Ananta Huaxiang Ltd. (Extension 2)

13 October 2025

Structural Inspection Report

Observation-01: Inconsistencies in the design report. (Building-D)

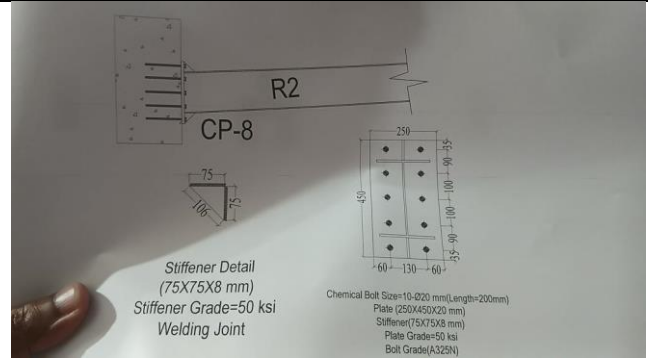
Description: During the inspection, the design report was found on-site, and the following observations were noted:

- The response modification coefficient, R, has been taken as 8, which is referred to as Special Reinforced Concrete Moment (SMRF). The factory is required to meet the requirements with BNBC 2020 articles 8.3.4, 8.3.5, 8.3.7 and 8.3.8. Also, the roof framing is steel while the lower stories (Ground Floor to 2nd) are reinforced concrete, the Building Engineer is required to justify the R value, addressing composite behaviour, ductility and detailing requirements.
- The structural system is reported as a Special Moment Resisting Frame. However, no joint shear (beam-column joint) checks have been provided.
- No torsional irregularity check has been provided.
- No foundation adequacy check was provided.

The building engineer is required to address all the inconsistencies in the revised EA report and submit the revised EA to RSC.

Observation-03: Loading on the 2F (Building D).

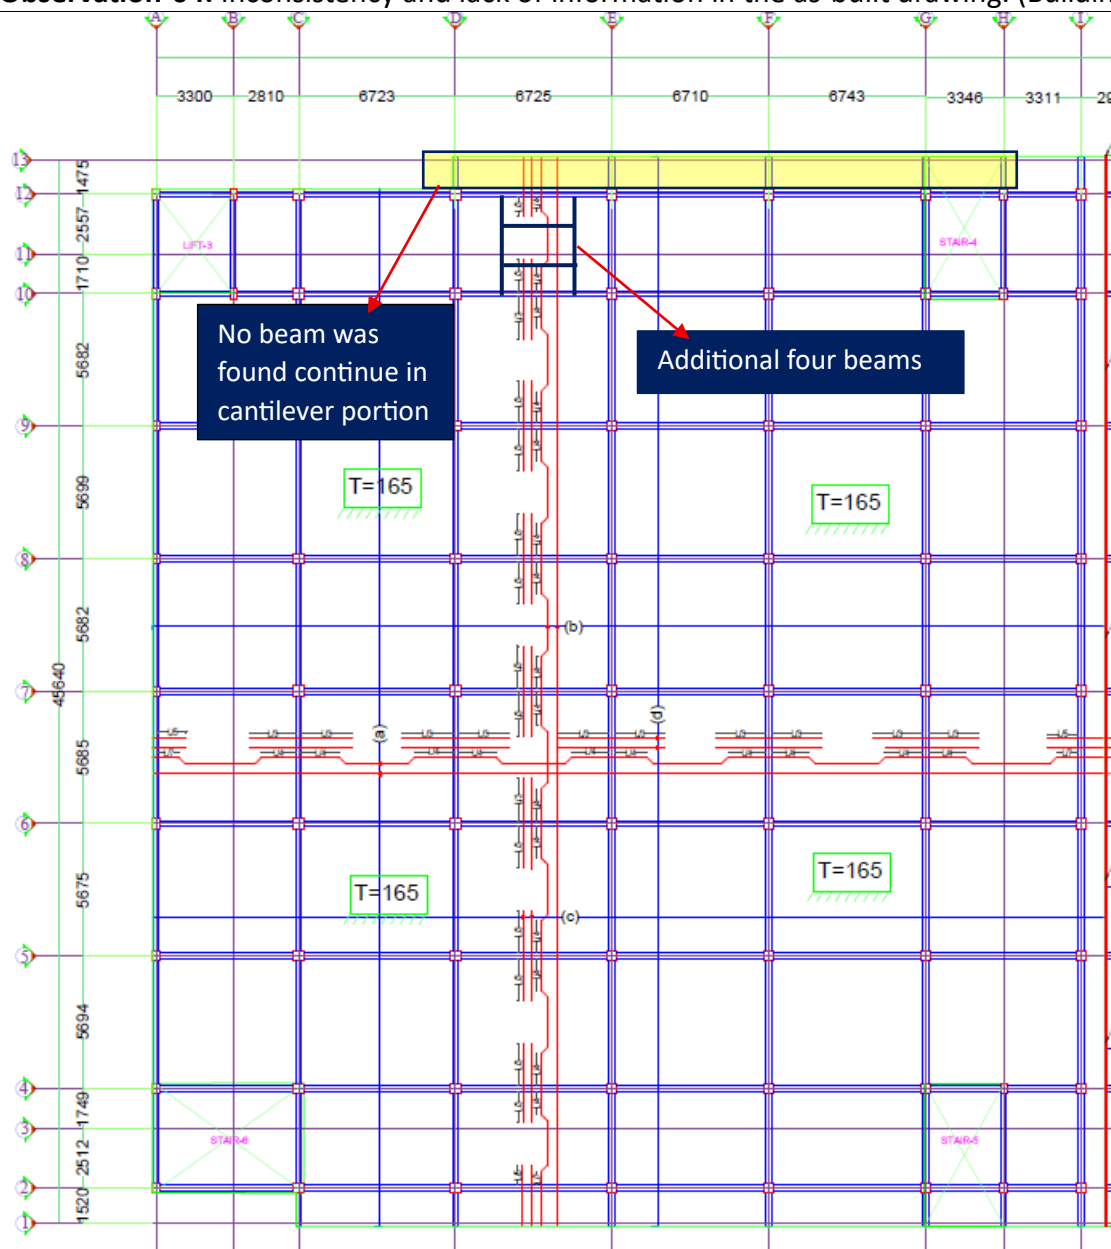
Description: Loading was found around 6 kPa on the 2F. Building engineer is required to prepare an interim load plan and maintain loading below 6 kPa. Also, implement a floor load management system. (Height marking, Signage).

GROUND FLOOR ROOF REINFORCEMENT DETAIL

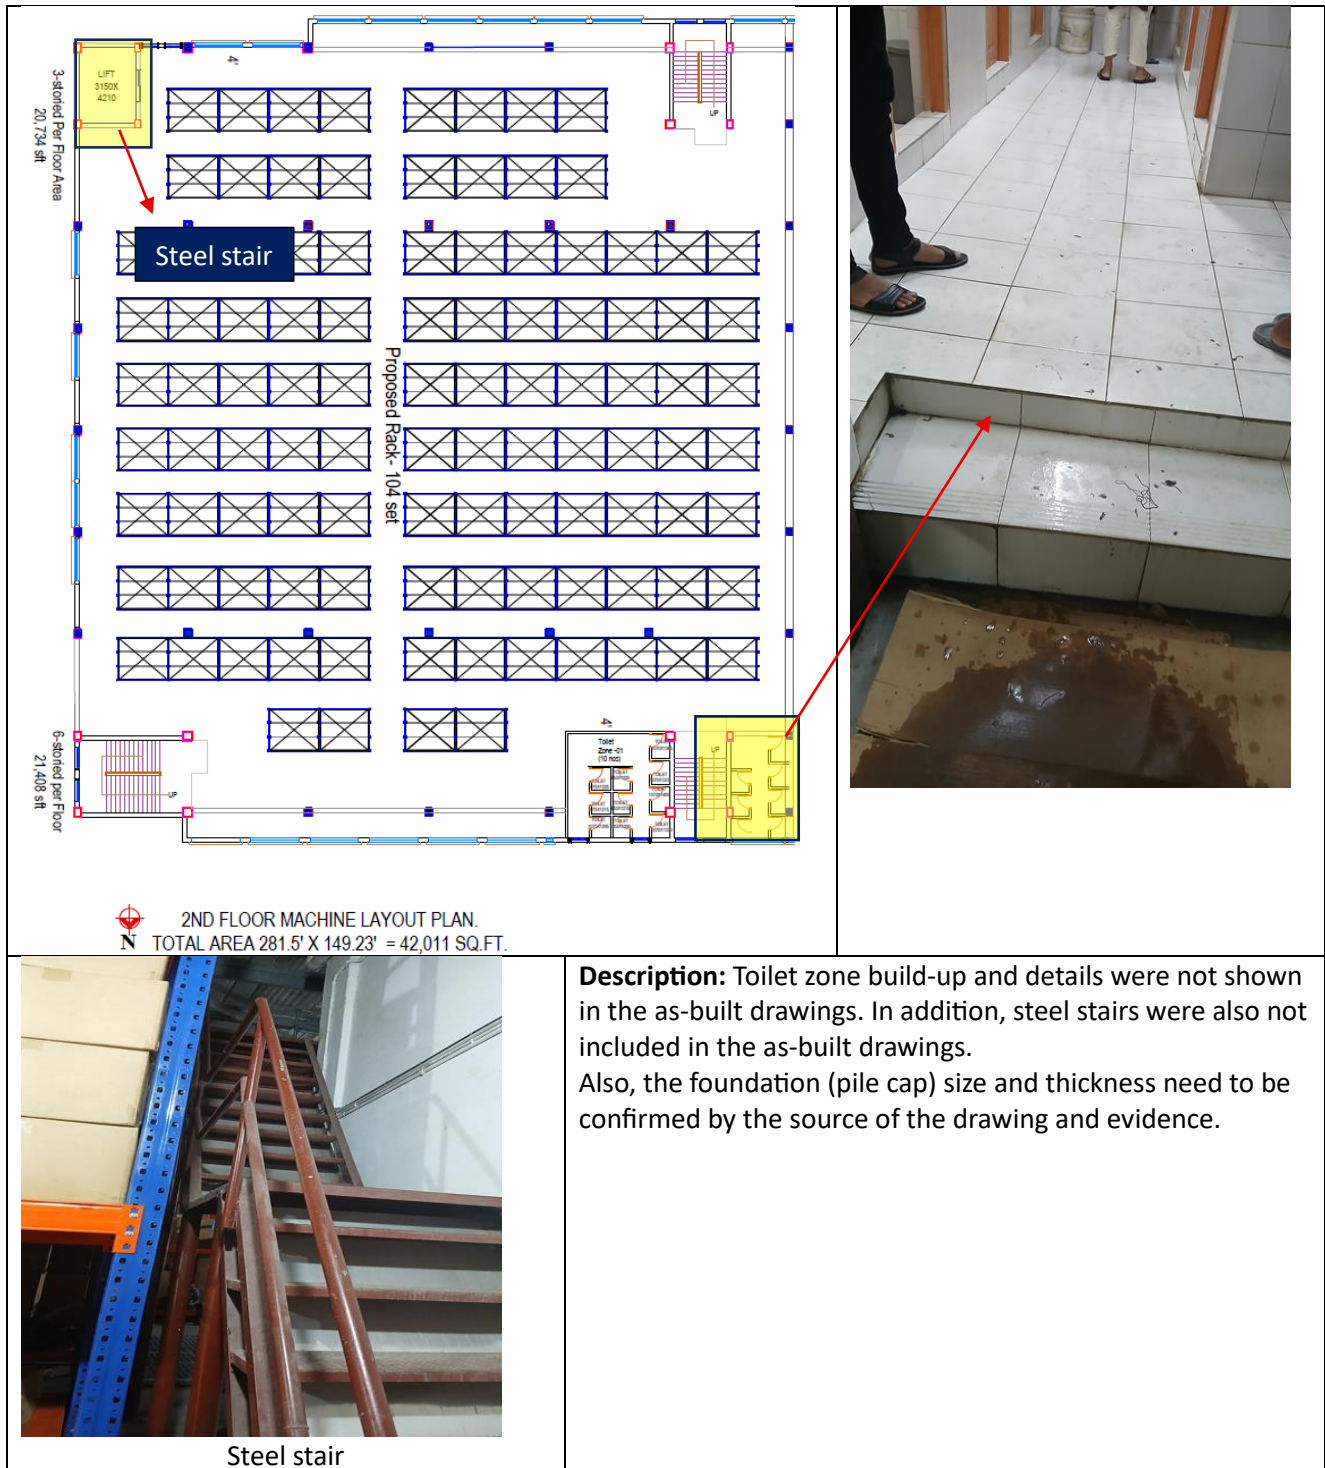
Description: During the inspection, no beam was found in the cantilever portion, and four additional beams were found at the GF roof.

6.	Inconsistency and lack of information in the as-built drawing. (Building-D)	The Building Engineer is required to confirm the source of the drawings to ensure the accuracy of foundation size and thickness, survey the structures, and prepare comprehensive as-built drawings.	within 6 weeks

Observation-08: Connection gap between steel plates. (Building D)

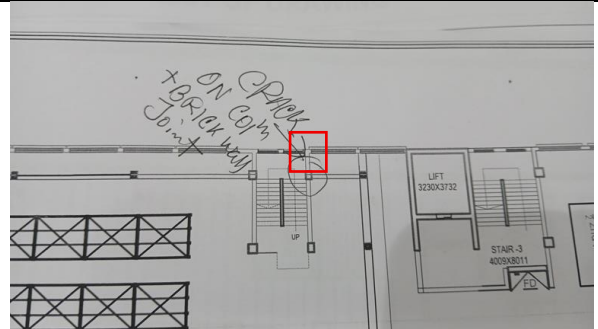
Description: Connection gaps were found in the roof shed areas. The building engineer is required to repair the gaps with a suitable method and ensure adequate strengthening where necessary.

Observation-09: Crack on column and brick wall joint. (Building D)

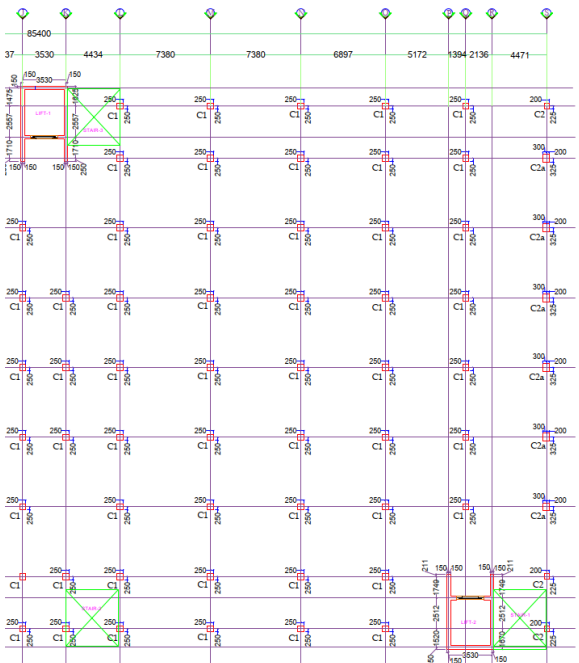
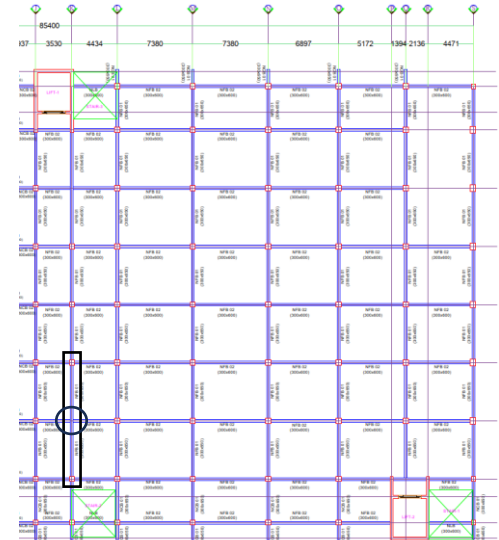
Description: Cracks were observed on the column and the brick wall joint. The building engineer is required to investigate the reason for the crack and repair it with a suitable method.

Observation 10: Column stressed above the normal design limit. (Building E)

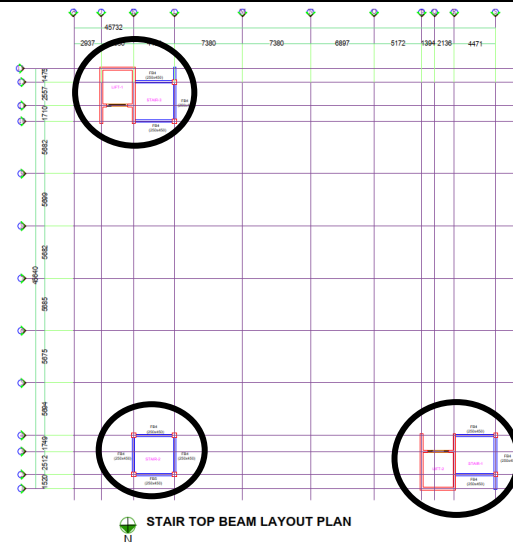
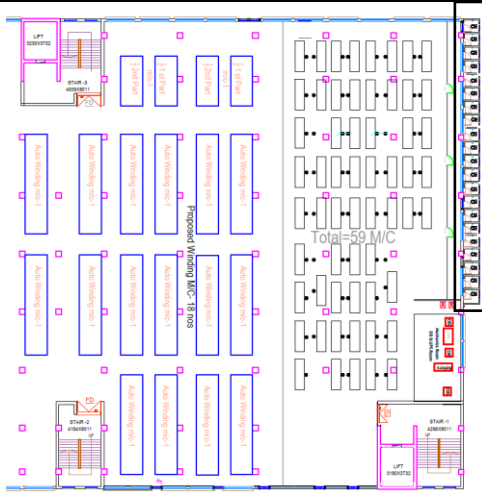
Column layout plan	Warehouse loading
Description: cursory calculations indicate that columns are stressed above the normal design limit, considering the observed live loads of 4 kPa for the typical production area & 6 kPa for the store area, with a minimum concrete strength based on the aggregate type. Building engineer is required to review the design, load, and column stress. Also, a beam was found 11.2 m due to the omission of a column. Building engineer is required to review the design of the beam.

12.	Column stressed above the normal design limit. (Building E)	Building engineer is required to review the design, load and column stress.	within 6 weeks

Observation-12: Loading on the 4F. (Building E)

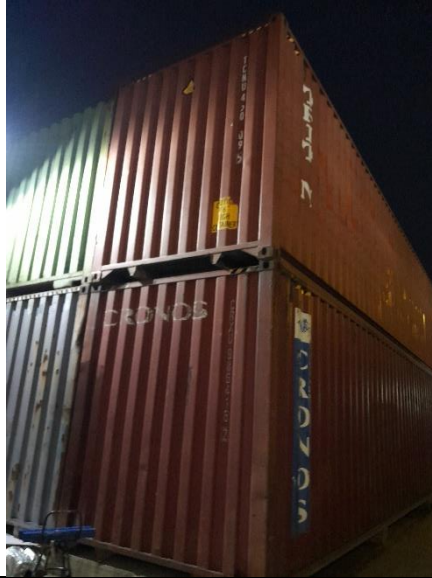
Description: Loading was found slightly above 6 kPa on the 4F. Building engineer is required to prepare an interim load plan and maintain loading below 4 kPa. Also, implement a floor load management system. (Height marking, Signage).

18.	Loading on the 4F. (Building E)	Building engineer is required to prepare an interim load plan and maintain loading below 4 kPa on the 4F.	within 6 weeks
